Wilton Conservation Commission

Re: Case # 03/11/2025-02, Letter 2

Date: April 8, 2025

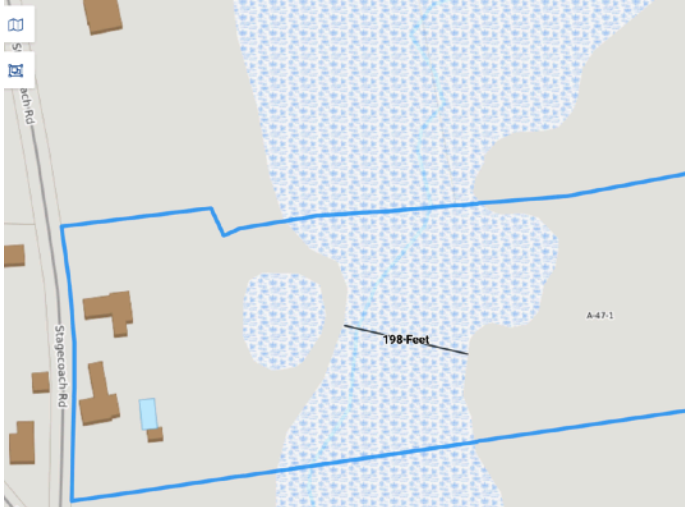
A more detailed scaled plan with exact locations and routes, dimensions of the proposed crossing, trail width, and length across wetlands soils, including slopes and fill details, with photos of existing conditions should be provided.

The Conservation Commission is unclear in terms of the overall impact area. The plan should provide exact details including the location of any permanent and temporary structures. We also would like to know if this trail and associated structures will be accessible to any motorized vehicles, as this further threatens water quality and requires specific design criteria to minimize those impacts.

Any permanent structure within a wetland will require a building permit and review by the Wilton Planning Board.

- Permanent wetland impact area calculations
- Temporary wetland impact area calculations
- Drainage detail which provides enough information to rule the project does not have impact on existing flow offsite
- More detailed topology including trail grades
- Wildlife specific mitigation measures such as culvert sizing
- Fill material definitions as specified on the plan as "gravel"

Gravel specified on this plan implies wetland impact.

Wildlife corridor data layer

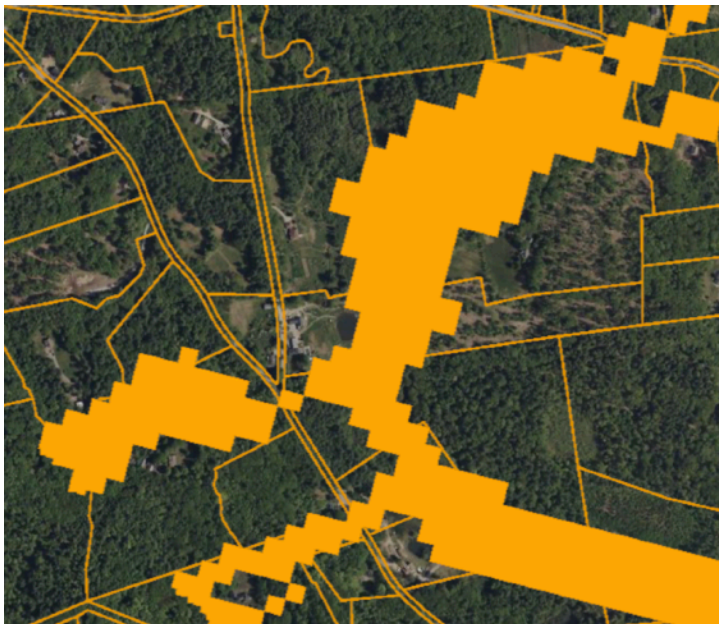
NH Granit View with the wildlife corridor overlay reveals that the trail location will be bisecting a wildlife corridor for this area. The applicant and ZBA should review any NHB hits and the impact to those species should be considered. The Commission is also requesting to review any correspondence or recommendations from New Hampshire Fish and Game
Source:
